SERVICE INFORMATION

PROBLEM: Neutral Positioning Bolt Boss Too Short

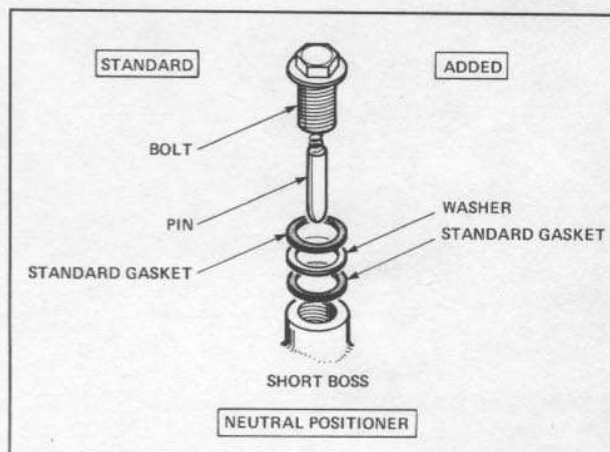
The 1976 KH500 has a neutral positioning bolt on the upper crankcase. On some early KH500's, the positioning bolt boss was machined too short. Installation of the positioning bolt and pin in a short boss may interfere with normal gear changing.

FACTORY ACTION: Installed Extra Gasket and Washer

All affected units have an added gasket and washer under the neutral positioning bolt.

DEALER ACTION: When Servicing Affected Units, Reinstall Added Parts

Check for the added parts any time the neutral positioner is removed, or whenever a customer complains of shifting problems on an affected unit.
